ADDENDUM NO. 1

The contract documents for the *Ozarks Electric 1st Floor Remodel* – FOR CONSTRUCTION PKG, dated 08/21/26 are hereby amended by this Addendum, dated 09/02/26 consisting of sixty six (66) pages.

4 WALL SECTION
3/4" = 1'-0"

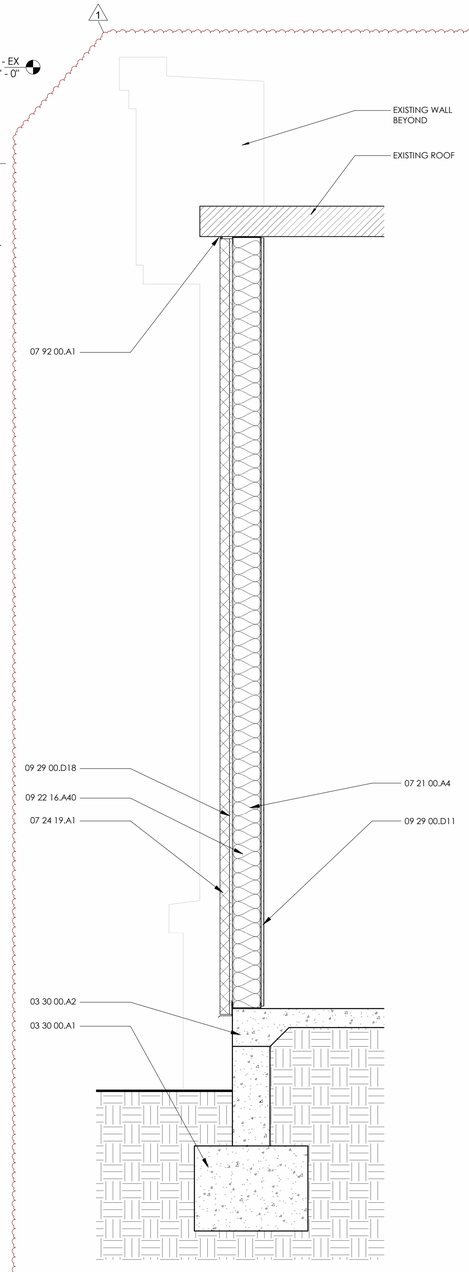
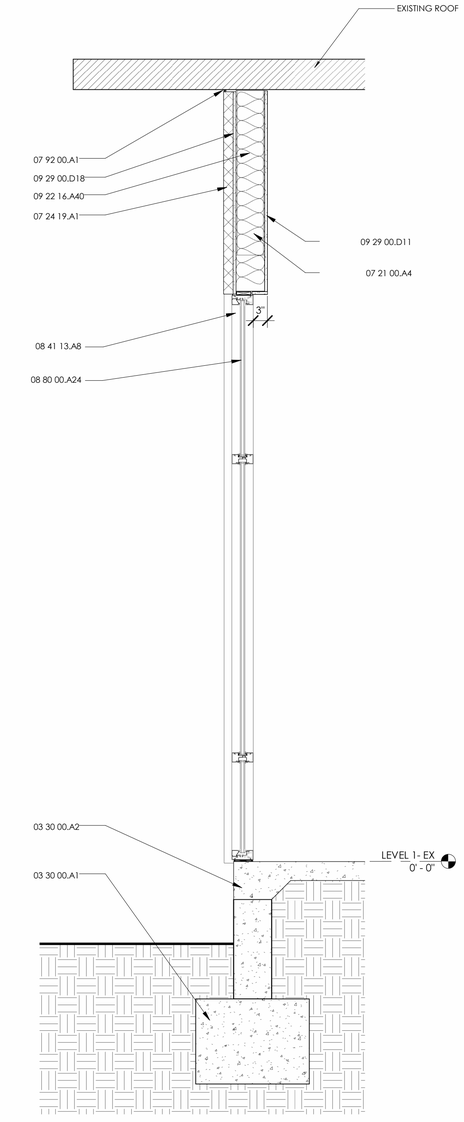
10. ***Revision:*** RE: A-201, “BUILDING ELEVATION”, provided new wall sections at MEETING ROOM C102.

PARTITION TYPE N

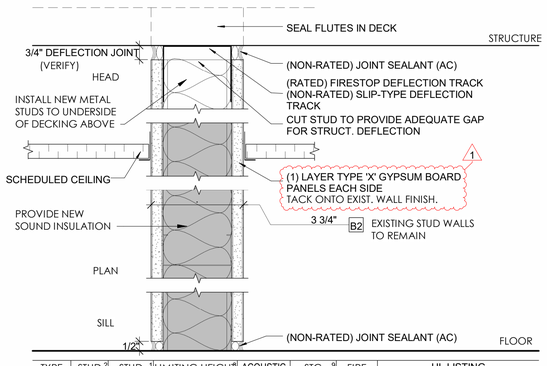
11. ***Revision:*** RE: A-301, “PARTITION TYPES”, revised partition type N and E for clarity.

1 MECHANICAL FLOOR PLAN - QUADRANT A
1/8" = 1'-0"

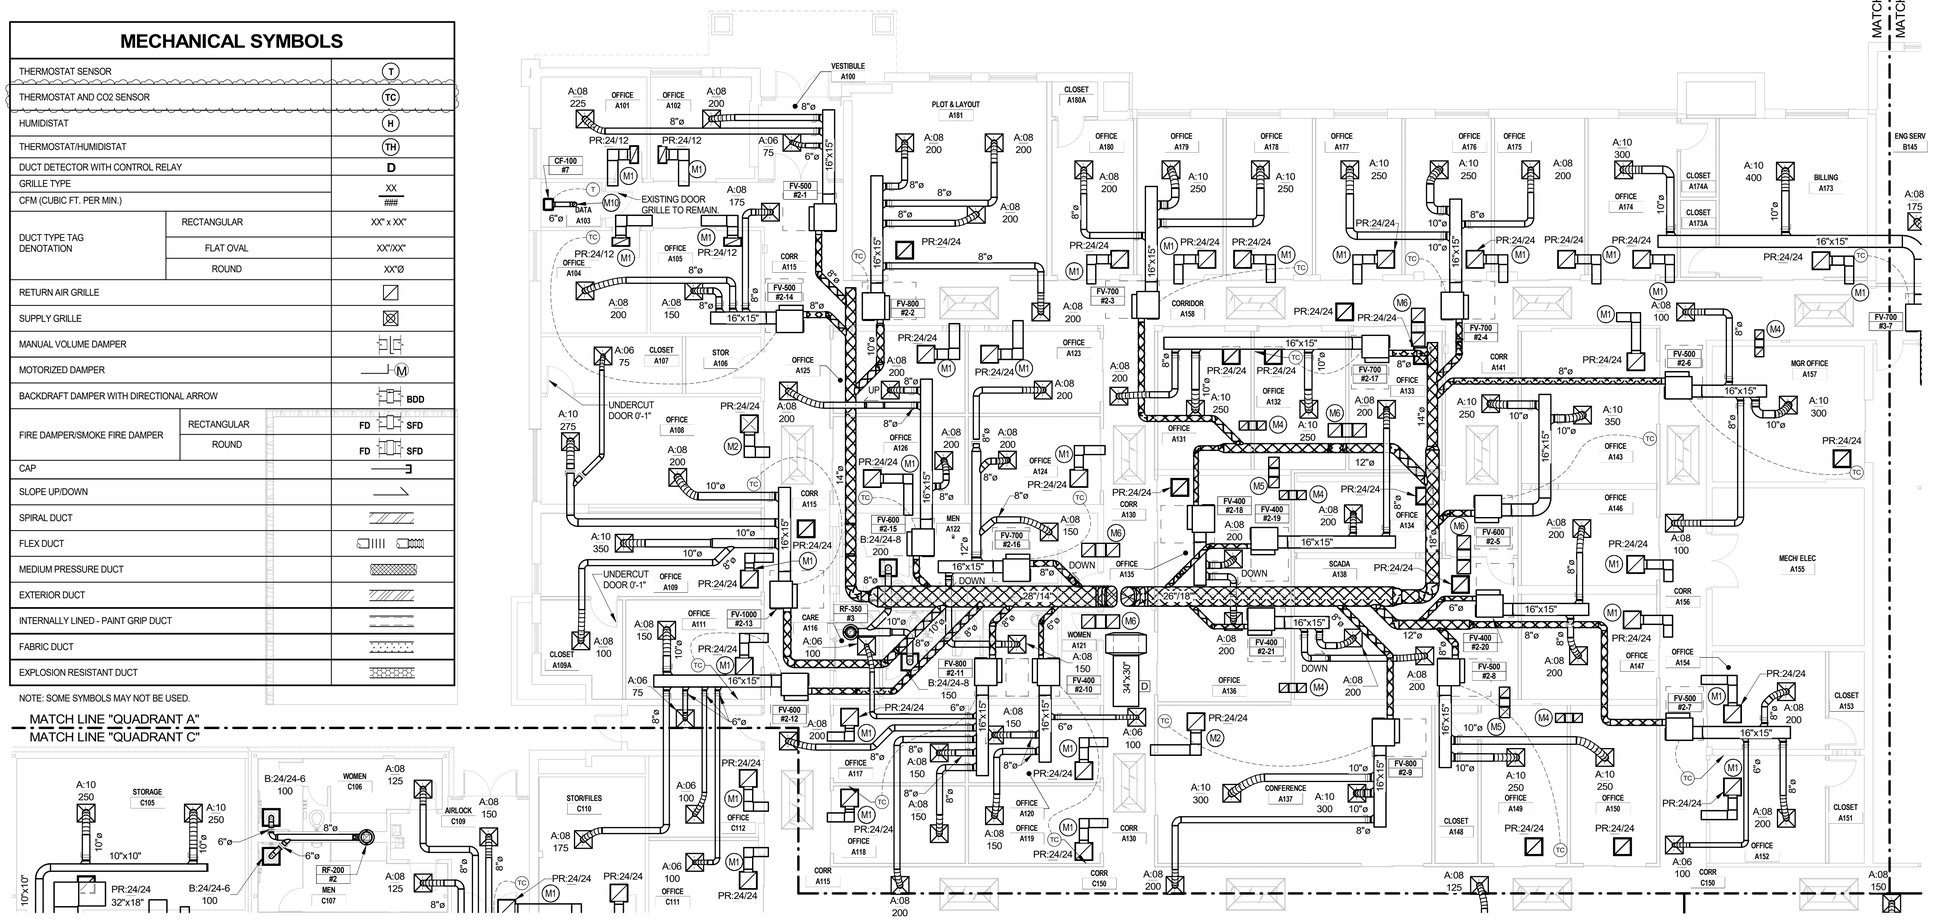
2.1. REFER TO SHEET M101A, MECHANICAL PLAN QUADRANT A:

2.1.1. Plan notes M4, M5 and M6 have been revised. Refer to the accompanying revised sheets for new notes.

1 MECHANICAL FLOOR PLAN - QUADRANT B
1/8" = 1'-0"

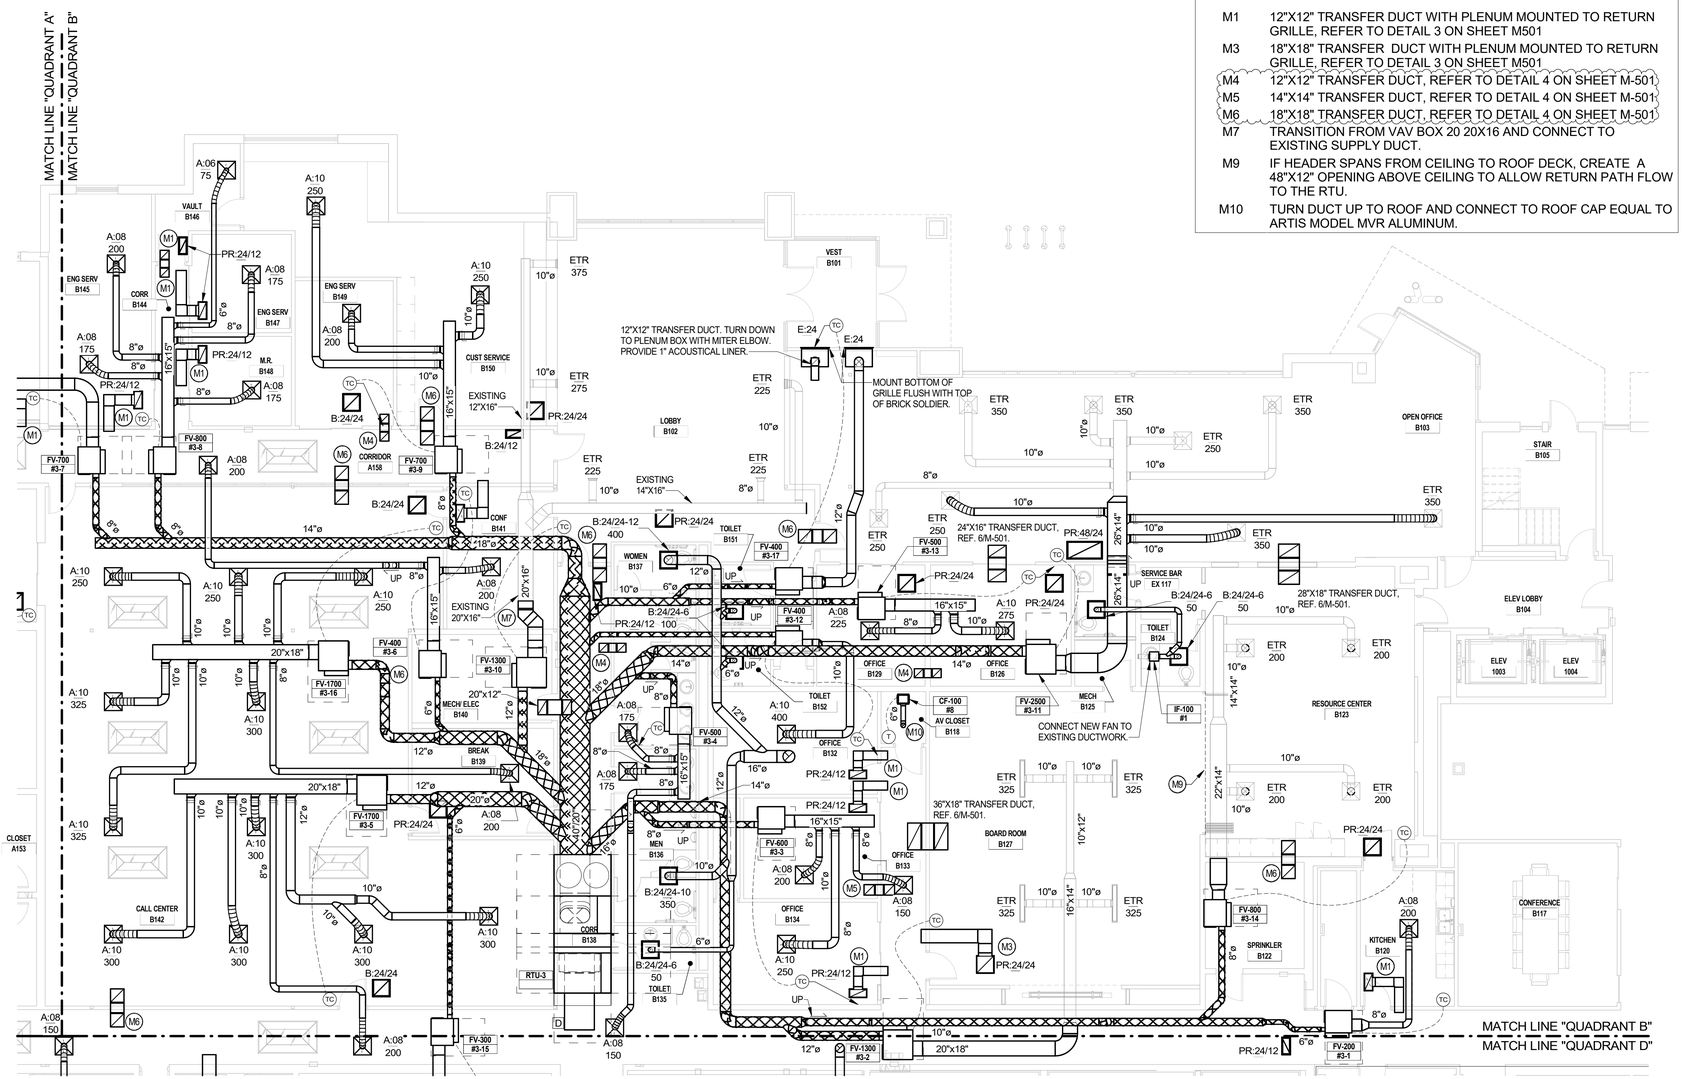
2.2. REFER TO SHEET M101B, MECHANICAL PLAN QUADRANT B:

2.2.1. Plan notes M4, M5 and M6 have been revised. Refer to the accompanying revised sheets for new notes.

1 MECHANICAL FLOOR PLAN - QUADRANT D
1/8" = 1'-0"

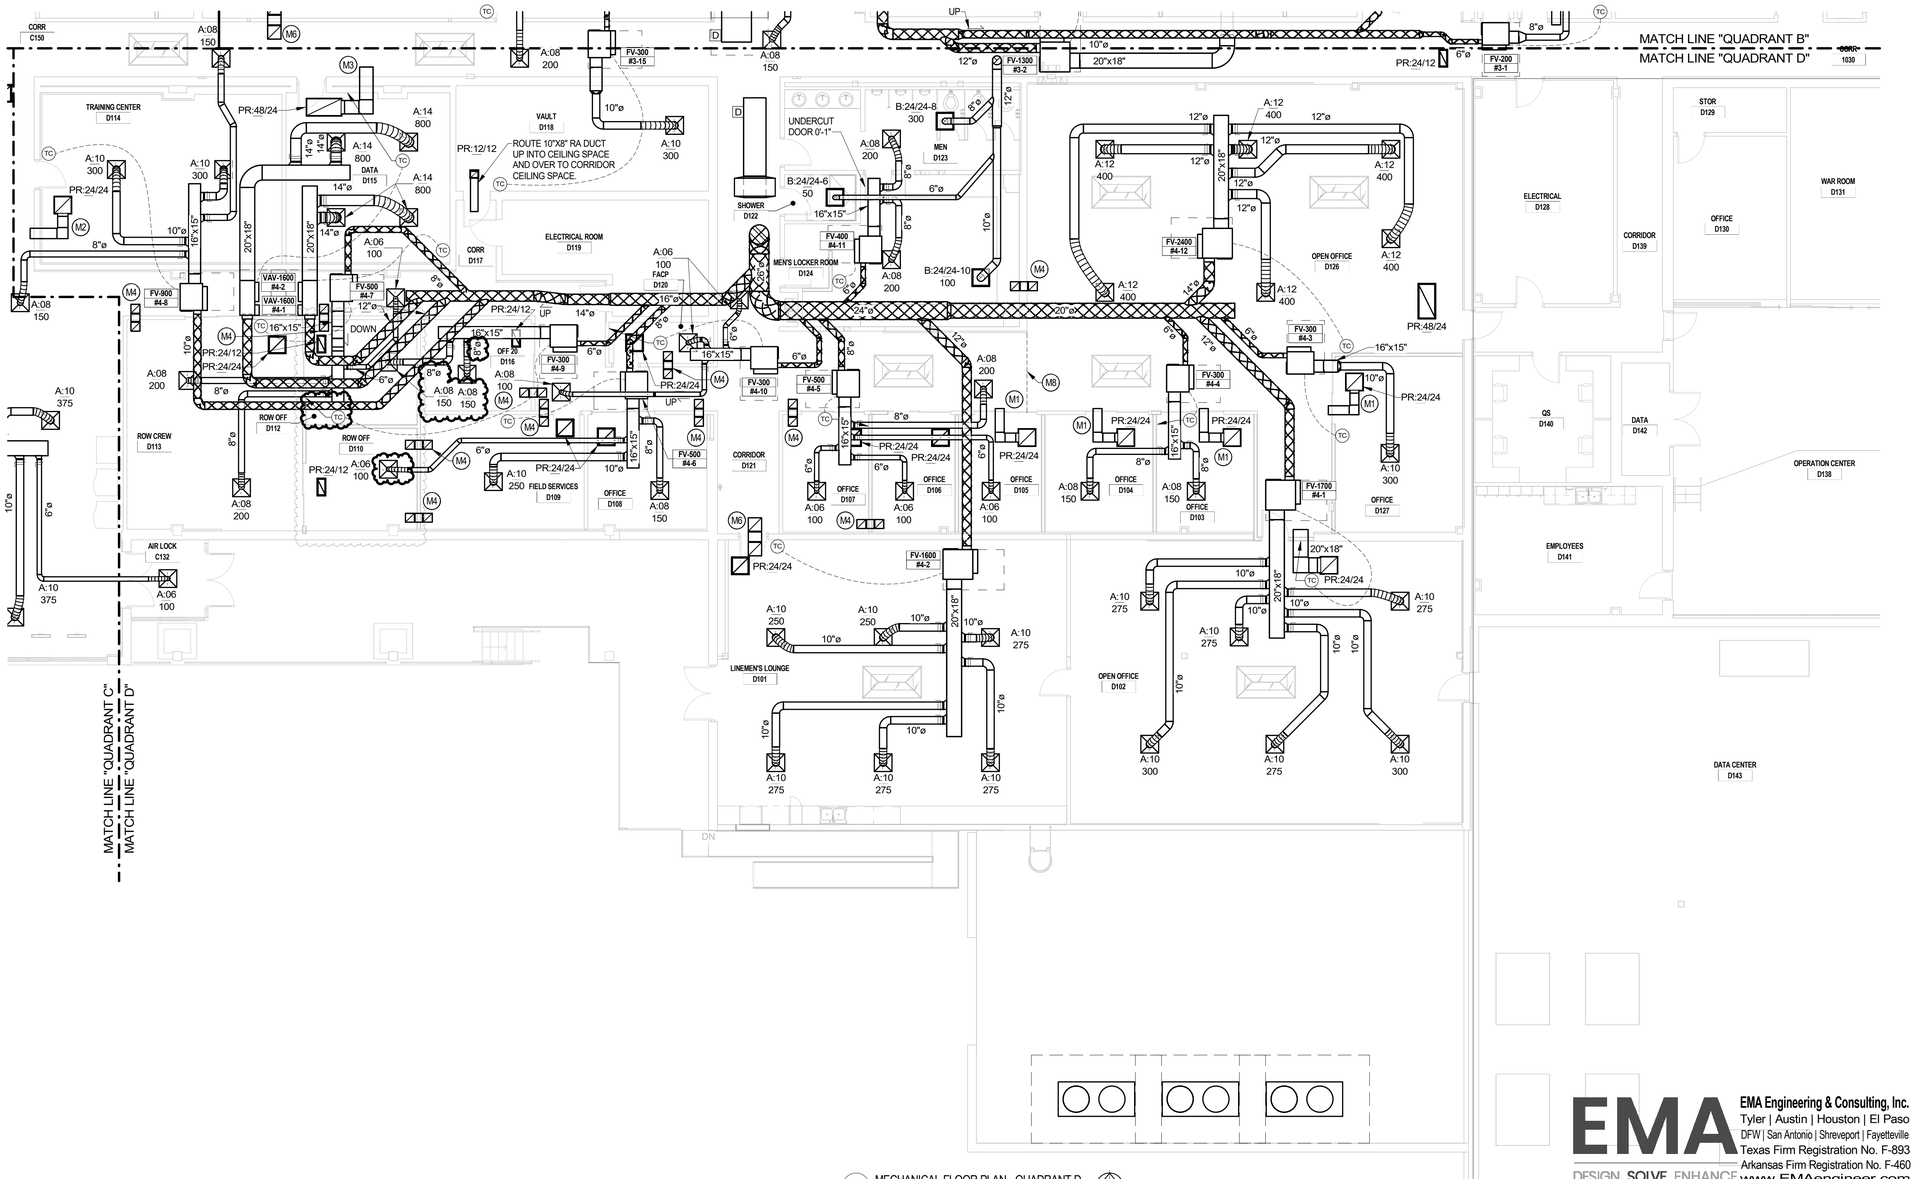
2.4. REFER TO SHEET M101D, MECHANICAL PLAN QUADRANT D:

2.4.2. Replace the existing exhaust fan in Electrical Room D119 with a new exhaust fan as follows. Fan shall be a domed centrifugal fan equal to Cook model 100-ACE-D for 300 CFM at 0.25" SP operating at 120 volts. Provide thermostat for fan control and backdraft damper and bird screen accessories. Mount fan on existing roof curb. Connect to power at lighting circuit in this room.

2.4.3. Row Office D111 has been removed and floor plan updated. See accompanying revised drawing for new work in this location.

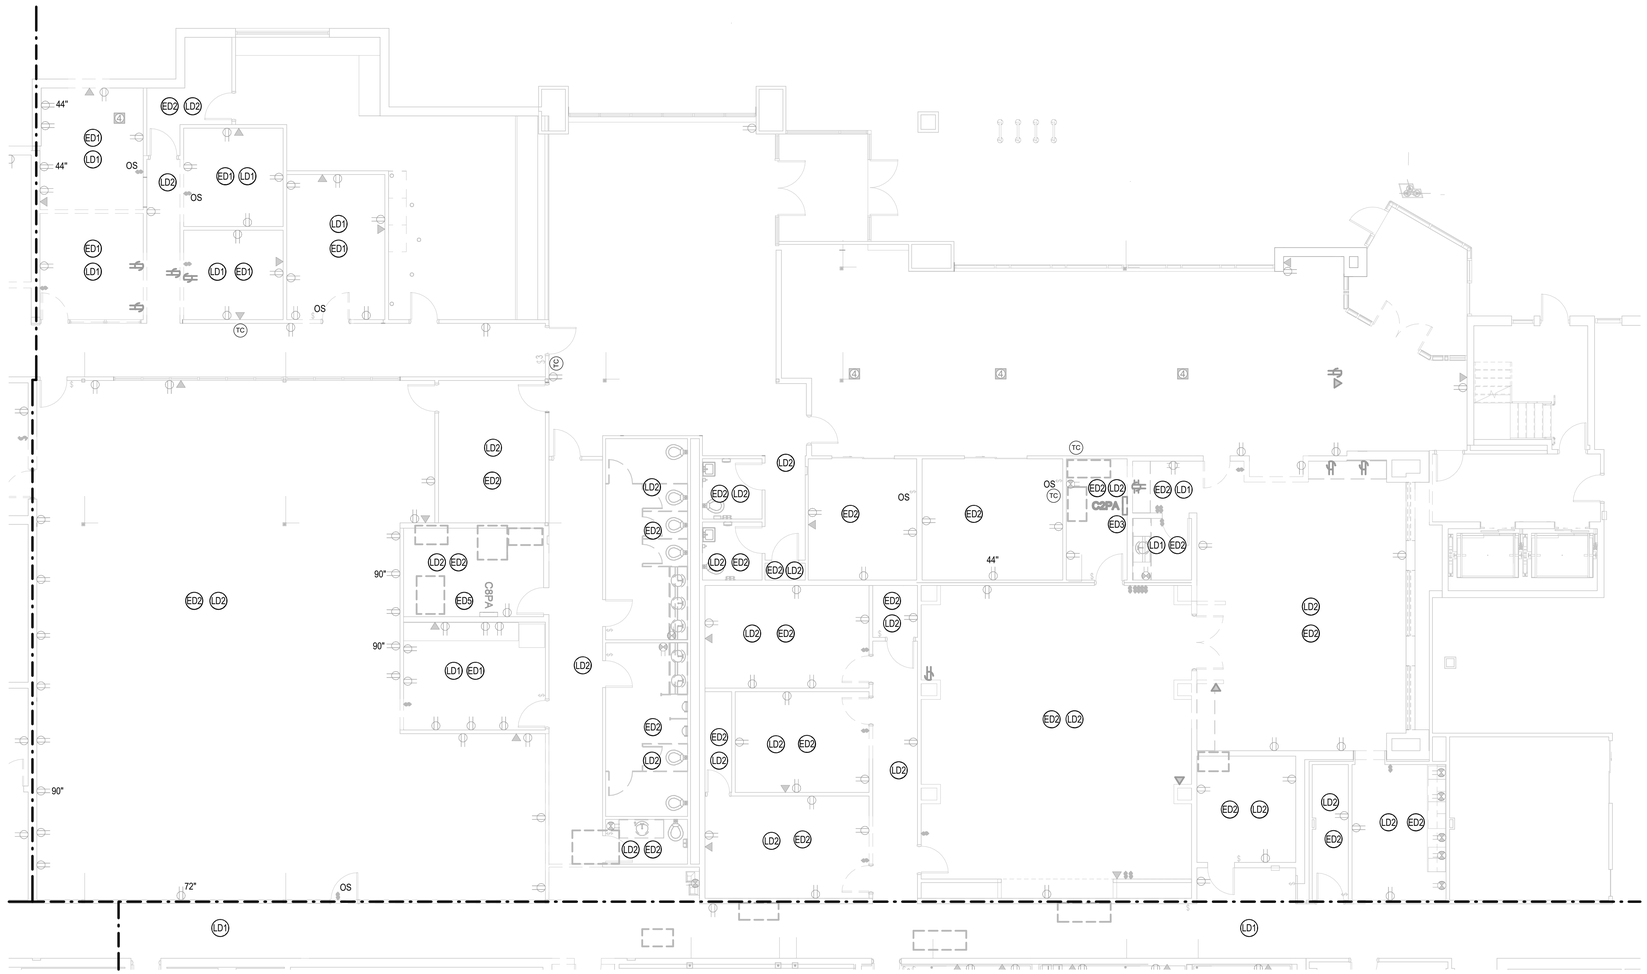
3.1. REFER TO SHEET ED101A, ELECTRICAL DEMO PLAN, QUADRANT A:

3.1.1. The only light fixtures to be salvaged and returned to the owner are identified by note LD2 on this sheet. Receptacles and switches identified by note ED2 may be reused as part of the new remodel work. All other devices and fixtures are to be demolished and removed from the building.

ED-101B

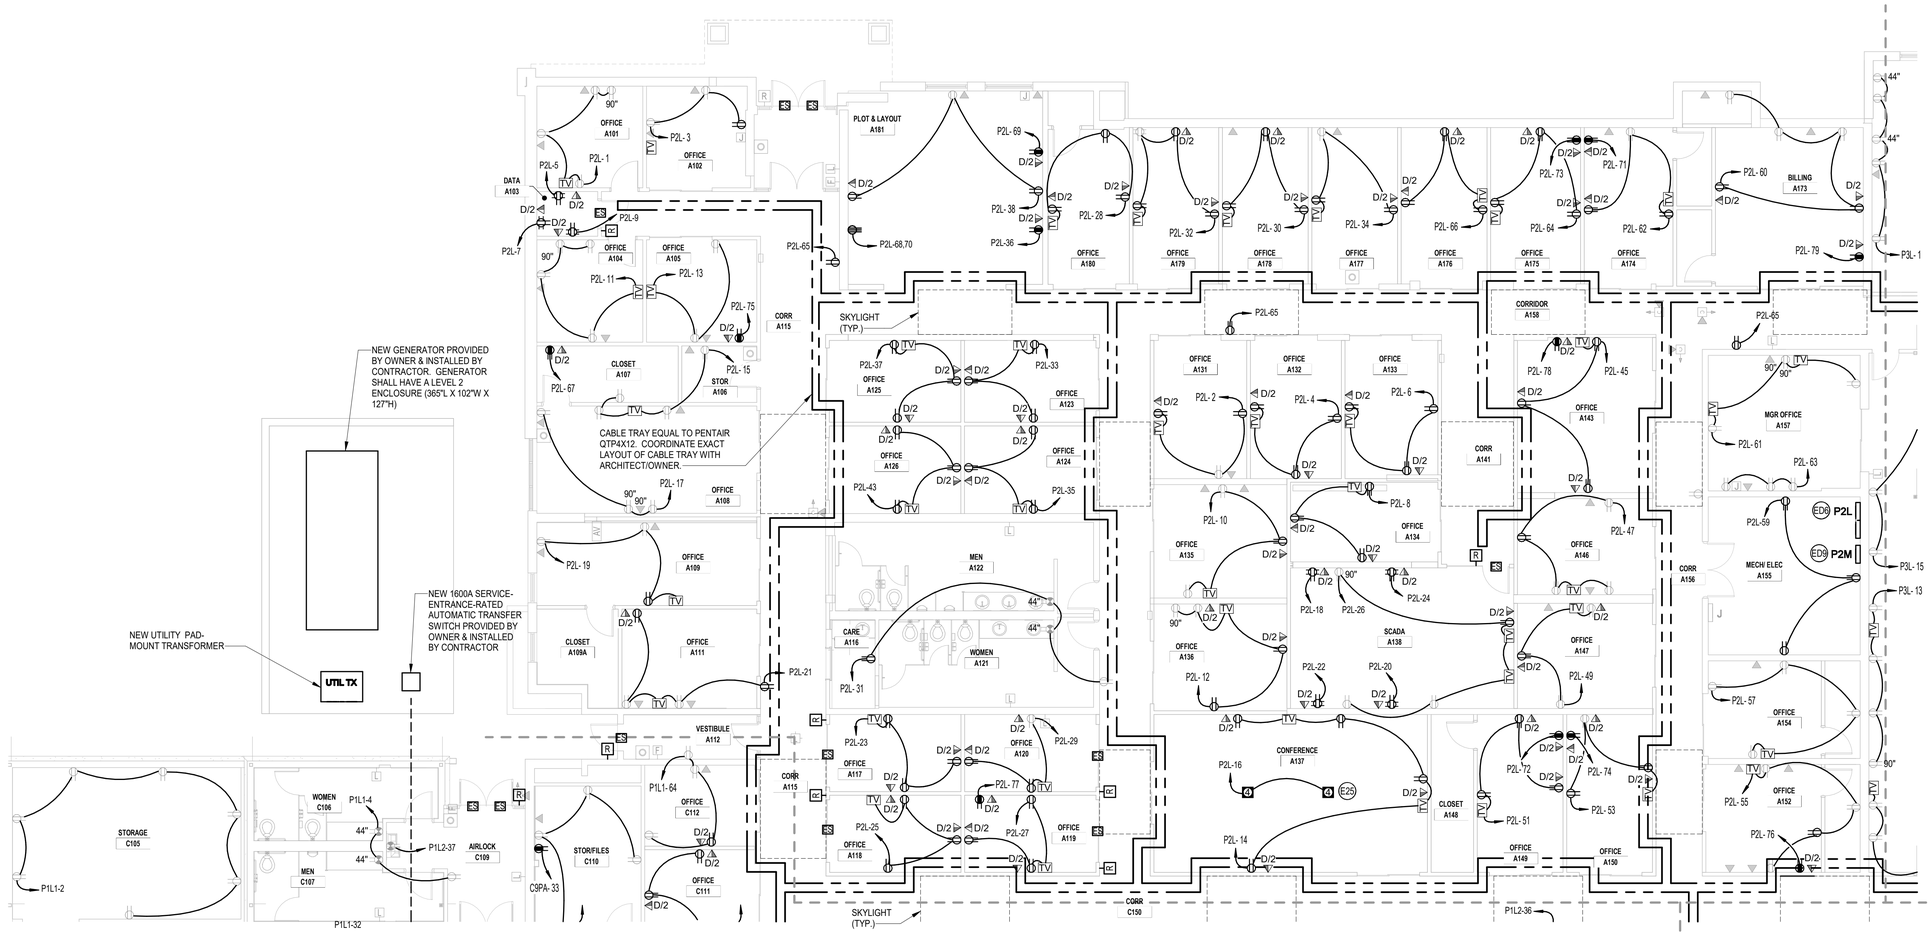
3.2. REFER TO SHEET ED101B, ELECTRICAL DEMO PLAN, QUADRANT B:

3.2.1. No demolition work occurs in rooms B150, B102 and B103. Delete the keyed demolition notes in these rooms.
